## ZONING BOARD OF APPEALS STAFF REPORT

REGARDING: 39465 Fourteen Mile Road, Parcel # 50-22-01-200-037 (PZ20-0018)

## MEMORANDUM

**TO:** ZONING BOARD OF APPEALS  
**THRU:** BARBARA MCBETH, AICP, CITY PLANNER  
**FROM:** LINDSAY BELL, AICP, SENIOR PLANNER  
**SUBJECT:** ZBA VARIANCE REQUESTS FOR 'BEHAVIORAL CARE SOLUTIONS' PZ20-0018  
**DATE:** MAY 13, 2020

SHEET  
SITE PLAN

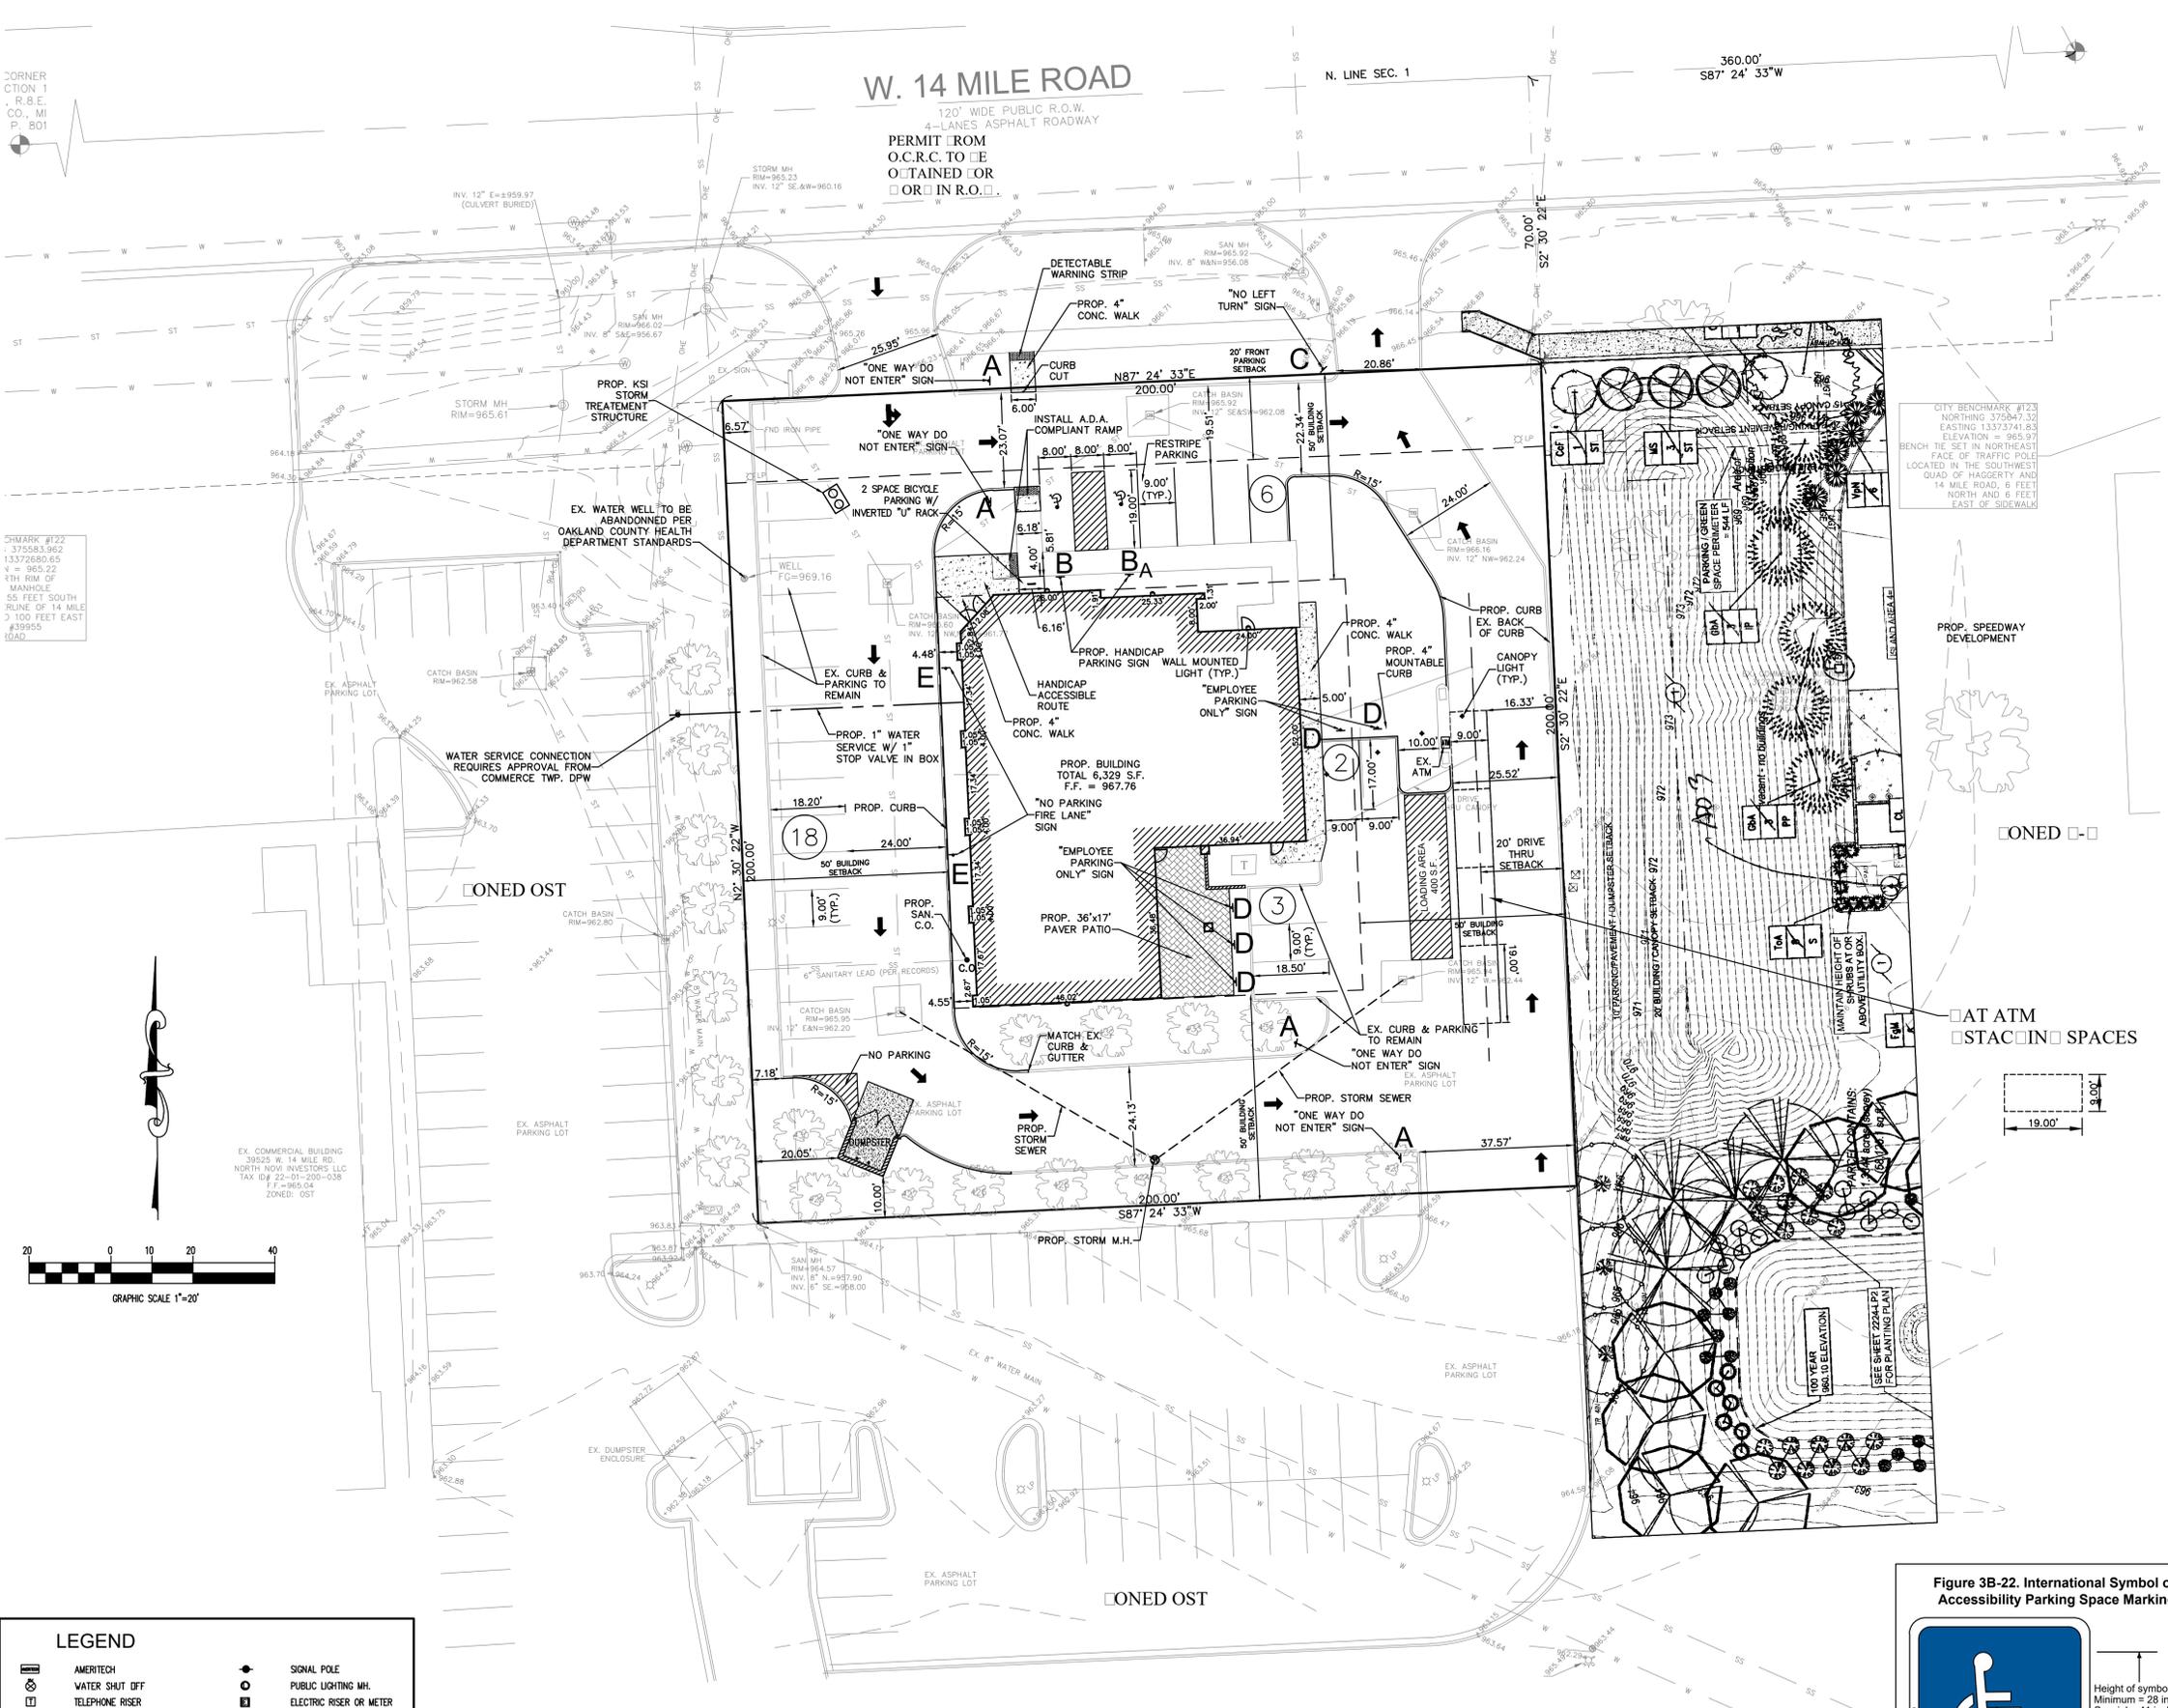
1. Drive-Through ATM (Sec. 5.3.11): The drive-through ATM was relocated to its current location on the outside drive aisle without formal review or receiving permits. **The site plan does not provide dimensions or details of the drive-through lane to demonstrate compliance with the ordinance requirements:**

- i. *Drive-Through lanes shall be separate from the circulation routes and lanes necessary for ingress to, egress from, the property. **The drive through lane is not separate from the egress lane - variance required.***

- ii. *Drive-through lanes and stacking spaces shall be setback from the property line a distance equivalent to the minimum parking setback (OST - 20 feet parking setback). **The drive-through lane is not 20 feet from the east property line - variance required.***

- iii. *Drive-through facilities shall provide one bypass lane (minimum 18 feet) to allow unobstructed travel for vehicles to pass those waiting to be served. **Plans show a 25 foot drive aisle. If the drive-through meets the minimum width of 9 feet, the bypass lane is only 16 feet wide. Variance required.***

- iv. *Drive-through lanes of financial institutions shall have a minimum of 3 vehicle stacking spaces, inclusive of the vehicle at the window. **Minimum of 3 stacking spaces must be shown on the plan, otherwise variance would be required.***

2. Loading Zone (Sec. 5.4.1): " Within the OS districts, loading space shall be provided in the rear yard..." **A variance is required from Section 5.4.1 to permit the loading area in the side yard.**
